**CITY OF LEWISTON  
PLANNING BOARD MEETING**  
Monday, August 13, 2012 – 5:30 P.M.  
City Council Chambers – First Floor  
Lewiston City Building  
27 Pine Street, Lewiston

**TO: Planning Board**  
**FROM: David Hediger, City Planner**  
**DATE: August 9, 2012**  
**RE: August 13, 2012 Planning Board Agenda Item IV(A)**

**Conditional use application to construct a telecommunications facility on property owned by Bernard and Jeannine Rancourt at 980 Sabattus Street by KJK Wireless on behalf of Maine RSA #1, Inc. (a.k.a. US Cellular).**

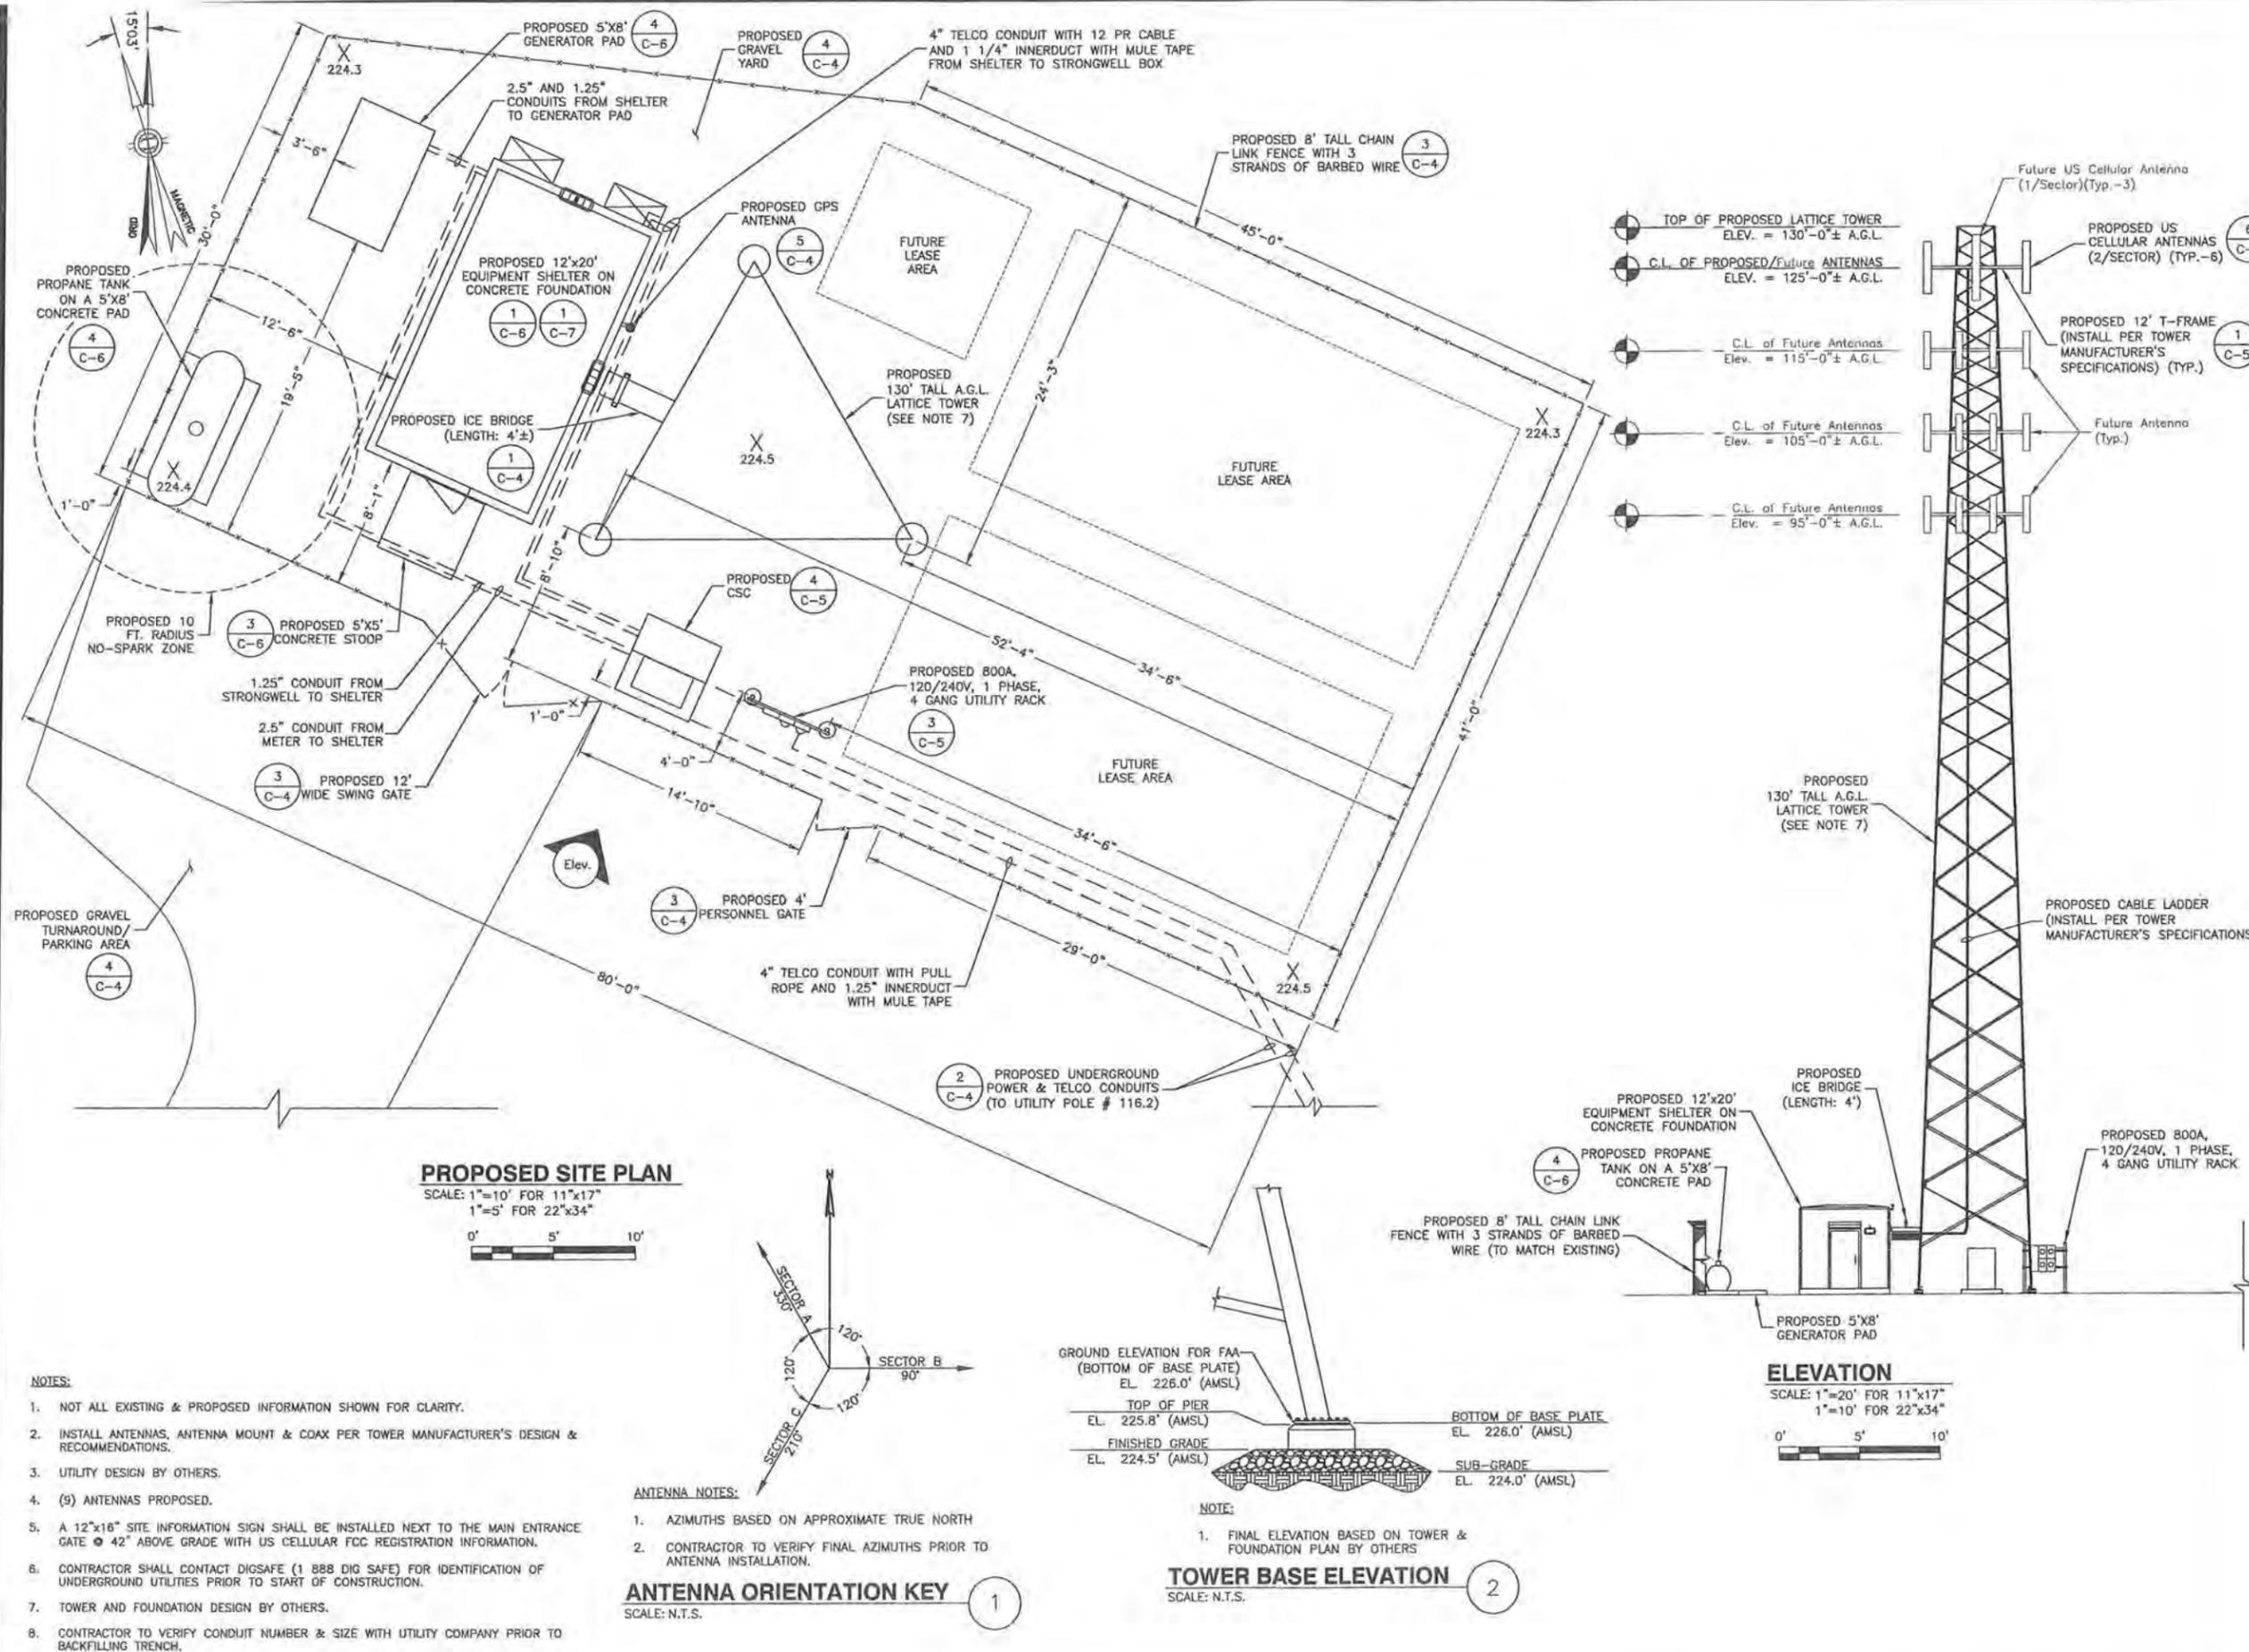
- The plan sheet number c-2 shows 14 shrubs to be planted around the perimeter of the leased area. The plan should note shrubs must be evergreen plantings a minimum of 3'-5' high upon planting.

1. Plan sheet number c-2 be amended to note shrubs must be evergreen plantings a minimum of 3'-5' high upon planting.
2. The conditional use permit be valid for a period of 24-months from the date of approval to be consistent with the 24-month expiration of development review approved projects. This should be noted on plan sheet t-1 as well as the expiration of approval language contained in Article XIII, Section 11.
